ASI-027-ASK-01

ENLARGED ARCHITECTURAL SITE PLAN

VA PALO ALTO POLYTRAUMA AND BLIND REHABILITATION CENTER

ASI-027-ASK-02

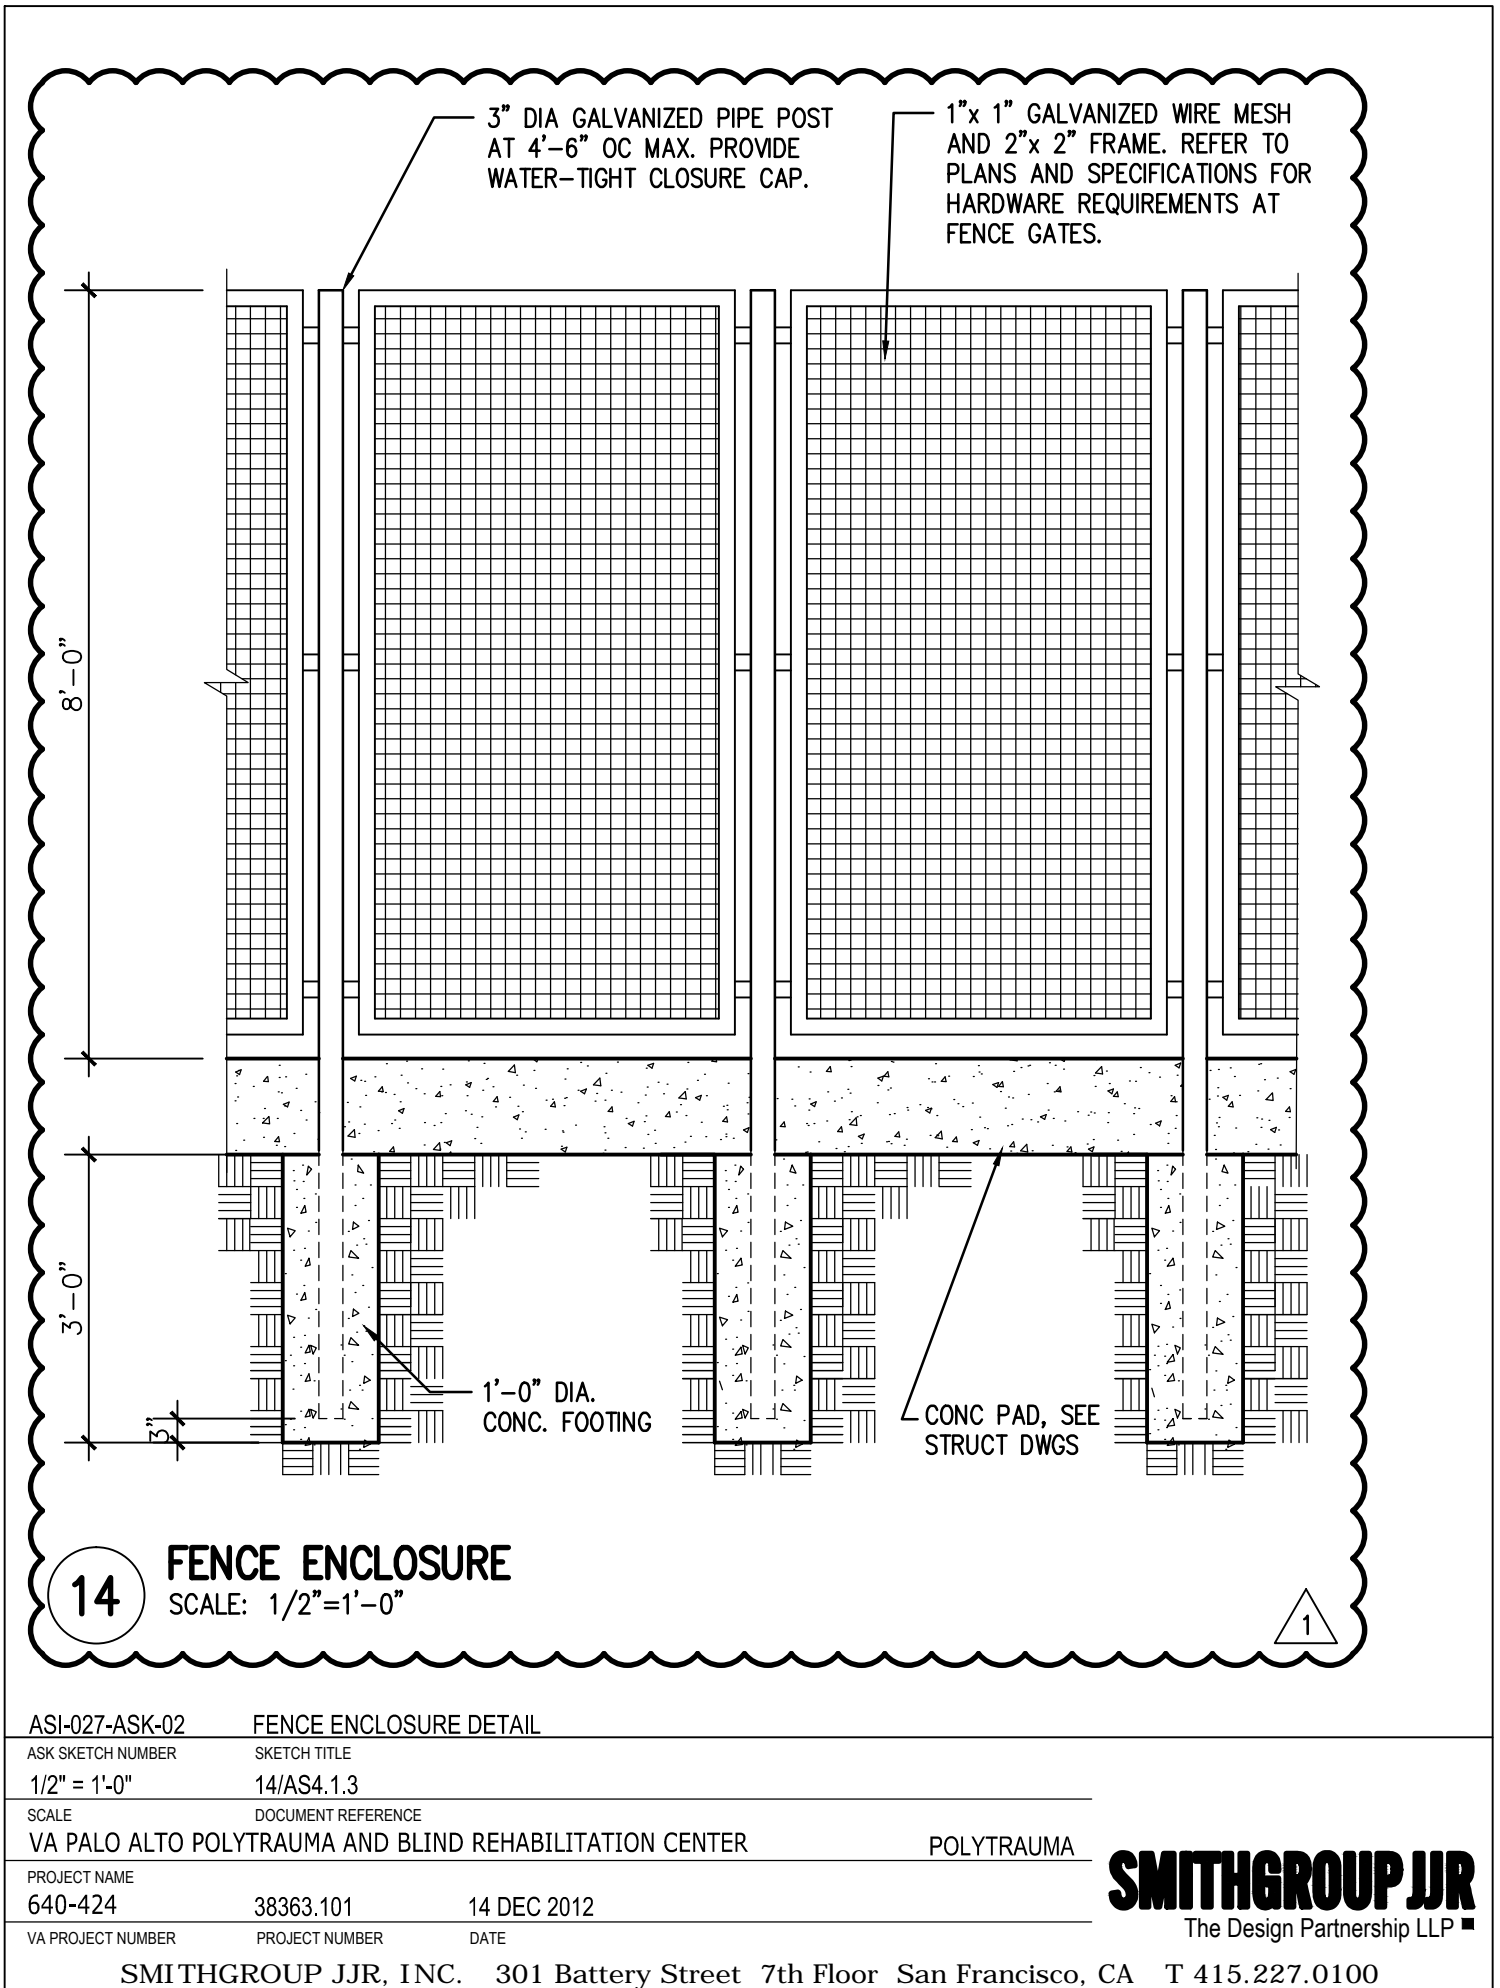
1.24 BULK OXYGEN STORAGE SYSTEM. PROVIDE FENCE ENCLOSURE WITH GATE PER DETAIL 14/AS4.1.3. GATE SHALL BE DOOR TYPE A2A PER AS9.1.1. PROVIDE THE FF HARDWARE: LOCK F07, STAINLESS STEEL HINGES (4) EACH LEAF, BOLT KEEPER, CANE BOLT, AND PADLOCK, TYPE AS REQUIRED BY MEDICAL CENTER.

1.25 FOR EMERGENCY OXYGEN INLET DETAIL, SEE 30/AE5.3.4. FOR O2 RISER AND PRV PENETRATION DETAIL SEE 24/AE4.3.4. SEE MECH DWGS FOR ADDL INFO.
